REVIEW (PART 1)
of
ASSESSMENT OF EPA's RESIDENTIAL WOOD HEATER CERTIFICATION PROGRAM
Test Report Review: Stoves & Central Heaters
Written by NESCAUM, March 2021

Reviewed by:
Thomas Morrissey
Woodstock Soapstone Company, Inc.
66 Airpark Road
West Lebanon, NH 03784
May 15, 2021

RED FLAGS FOR “SQUARING” AND “DEBARKING”

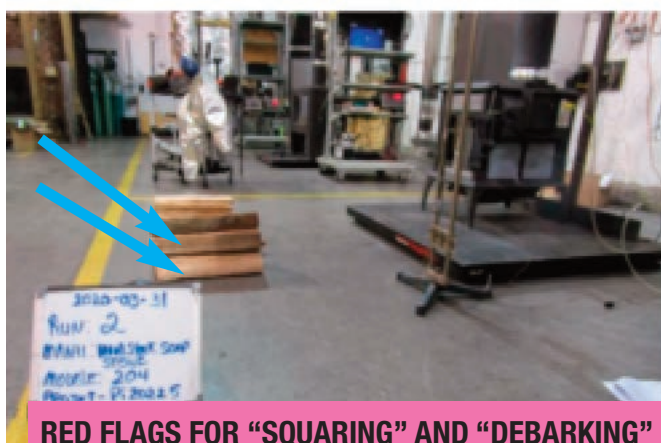
Below are photographs of the test fuel loads used for Model 202/204 that NESCAUM/ADEC reported were “debarked” over 50%, and “squared “over 50%”.

I submit that the pictures above show cord wood loads that meet the explicit terms defined in the Johnson Emails, as well as the (similar) characteristics defined in ASTM E-3053. I also submit that the findings of NESCAUM/ADEC that these loads have been “debarked” and “squared” is evidence of bias and misconduct in their data collection method.

Photo of Model 205, flagged for "Debarking" AND "Squaring"

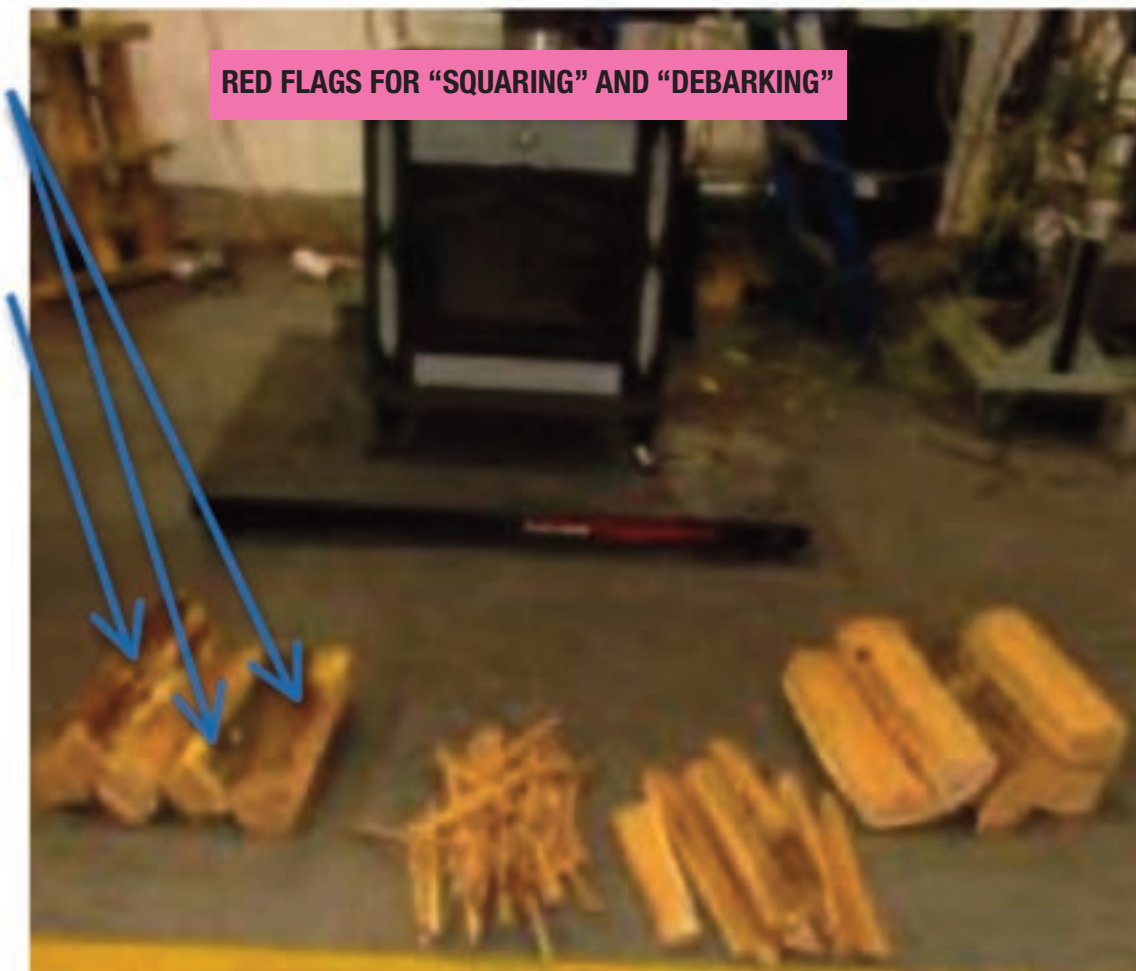
The “Assessment” claims that “90% of the stoves tested using ASTM E-3053 used debarked wood or failed to provide information about whether there was bark on the fuel.” (Assessment page 38) The “Assessment” further claims that “61% of the stoves tested with ASTM E-3053 used squared wood for more than 50% of the pieces” (Assessment page 33), including the stove immediately above (Model 205) and the fuel for Model 202/204, pictured on pp 10-11.

These pictures are not what NESCAUM/ADEC represent them to be - i.e., evidence of tampering with test fuel by stripping off the bark and squaring it to resemble dimensional lumber. You can see it with your own eyes.
